MINERALS PROGRAM INSPECTION REPORT PHONE: (303) 866-3567

MINE NAME:	MINE/PROSPECTING ID#:	MINERAL: COUNTY:
GolddiggerI	P-2009-007	Gold Park
INSPECTION TYPE:	WEATHER:	INSP. DATE: INSP. TIME:
Monitoring	Cloudy	September 14, 2022 08:00
OPERATOR:	OPERATOR REPRESENTATIVE:	TYPE OF OPERATION:
Chris Garrison	None	MP - Mineral Prospecting
REASON FOR INSPECTION:	BOND CALCULATION TYPE:	BOND AMOUNT:
Normal I&E Program	Partial Bond	\$4,307.29
DATE OF COMPLAINT:	POST INSP. CONTACTS:	JOINT INSP. AGENCY:
NA	U.S. Forest Service	None
INSPECTOR(S):	INSPECTOR'S SIGNATURE:	SIGNATURE DATE:
Elliott Russell	At Pmill	January 20, 2023

Photo 1. Site overview from FS 659; looking east.

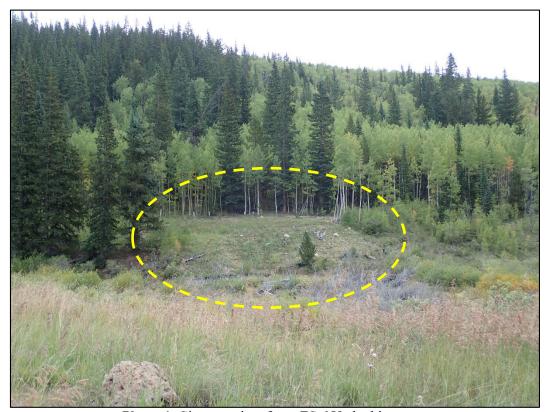
Backfilling and Grading: The site was adequately backfilled and graded.

<u>Revegetation</u>: The disturbance area had topsoil replaced and had been seeded with approved reclamation seed mix. The vegetative cover reestablished on the disturbance areas matches adjacent off-site areas. No noxious weed infestations were observed on the revegetated disturbances.
